August 15, 2023 Business Meeting Memo

SPR-22-0074: Rea Residence

Site Plan Review to deconstruct the existing residence and accessory Request:

Figure 1: Comprehensive Plan map showing identified wetland area shaded in blue

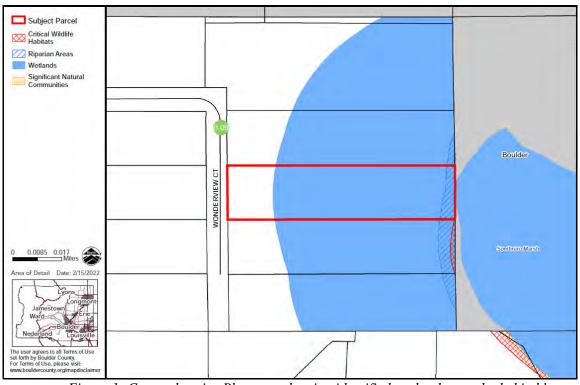
The Boulder County Comprehensive Plan identifies the eastern two-thirds of the subject parcel as a wetland area, as shown in Figure 1 below. As illustrated in Figure 2, the application materials included a wetland report indicating that the only actual wetlands extend onto a small area of the southern adjacent parcel. No development is proposed to take place in the wetlands identified by the applicant's report.

design. Therefore, staff do not find any conflicts with this standard because the septic system and residence have been designed to be located as far as possible from the wetlands to the east.

Figure 3: Existing site plan submitted with the original application materials indicating a 49' 8" setback for the existing residence, as well as similar setbacks on nearby parcels to the south.

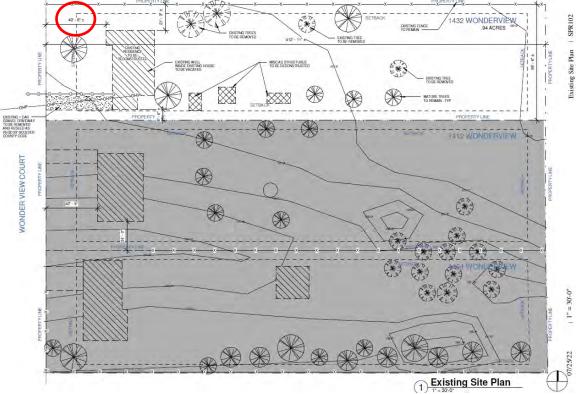
The submitted application materials include an existing site plan exhibit indicating that the existing (to be deconstructed) residence is located at an approximate 49' 8" setback from the western (front) parcel boundary (See Figure 3, below). The original proposal for redevelopment of the subject parcel indicated that the new residence would be located at a much larger setback of 193' 7" from the western parcel boundary.

Staff raised concerns that such a substantial setback would be significantly out of character with the existing pattern of development in the defined neighborhood, where nearly all of the residences are located very close to the front property line and have expansive rear yards. The adjacent property owner to the north also submitted comments expressing concerns with the proposed location of the residence, indicating that it would not match the character of the neighborhood and would present an imposing façade over their back yard.

Staff still have significant concerns regarding the substantial change in the setback between the residence and the western parcel boundary because the predominant pattern of development within the defined neighborhood places residences much closer to the front property line than has been proposed by the applicant. The proposed location would conflict with the visual character of the defined neighborhood, would pose a negative visual impact to the adjacent northern neighbor, and is a cause for concern related to impacts on the Sombrero Marsh as described in the BCPOS referral response.

However, the Site Evaluation and Engineered Septic Design provided with the revised application materials indicates that the best location for the required septic system is on the west side of the residence. The revised submittal also included an overall conceptual site plan for the subject parcel and two adjacent parcels to the south (which are also under active Site Plan Review) to illustrate that the increased setback was a function of the required setbacks between the septic systems and water wells on all three parcels. Therefore, the proposed location for the residence is approved as proposed in the revise application materials described in the chart above.

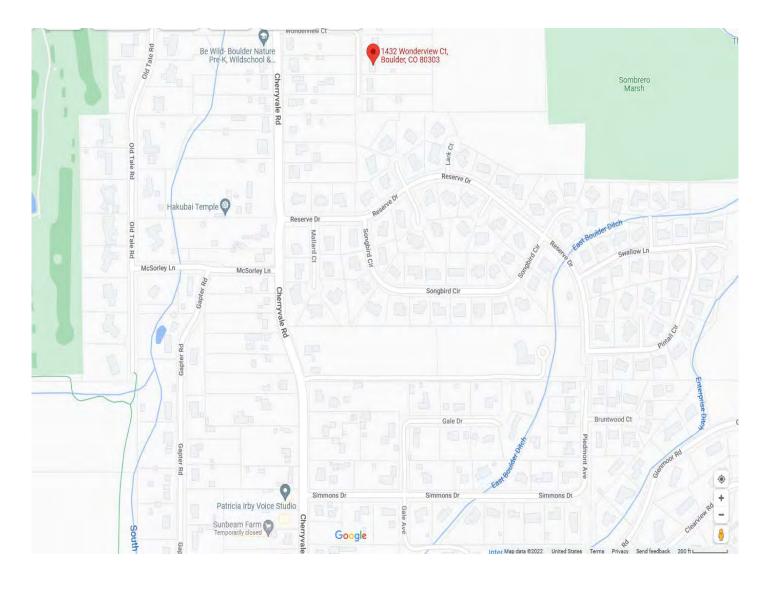
To be consistent with Boulder County Standards (2, 4, 10, 14, 10) and the goals of the Boulder Valley Comp Plan, the site plan should be altered in the following ways:

- 1. The replacement structure should be placed on or near the existing house.
- 2. The house should be reduced to one story.
- 3. The property should not be allowed to be elevated with 2.5 feet of fill dirt.

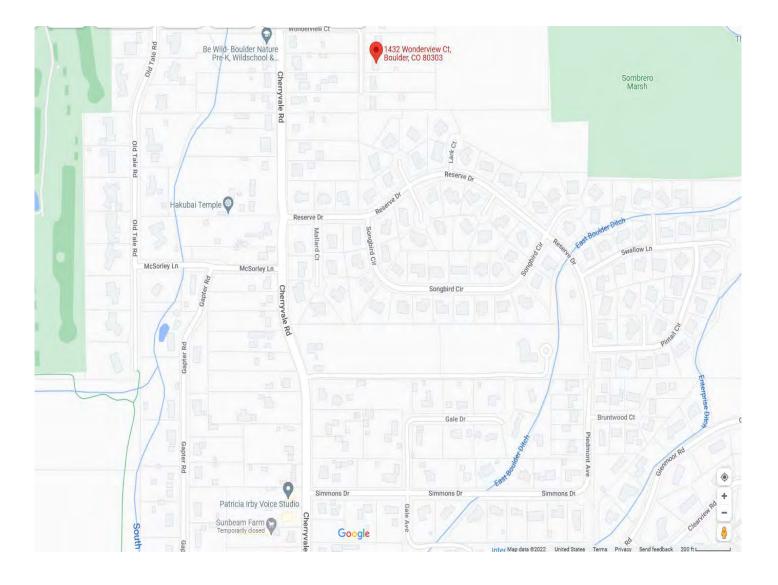
- Locating the replacement structure 197 feet from the road would create significant visual impact to our property and other adjoining properties. Currently, the houses on this street are not visible from the back yards.
- As noted in the letter from Boulder County Parks and Open Space, a large house with a second story near the wetlands would create adverse impacts of light and glare to for adjacent Sombrero Marsh.

OPEN SPACE IMPACTS - As noted in the Boulder County Open Space response this is a very unique area which supports a healthy aquatic ecosystem full of birds. Additional light and glare close to the marsh will have a negative impact on the wildlife.

To be consistent with Boulder County Standards (2, 4, 10 & 14) and the goals of the Boulder Valley Comp Plan, the house location should be denied. The replacement structure should be placed on or near the existing house.
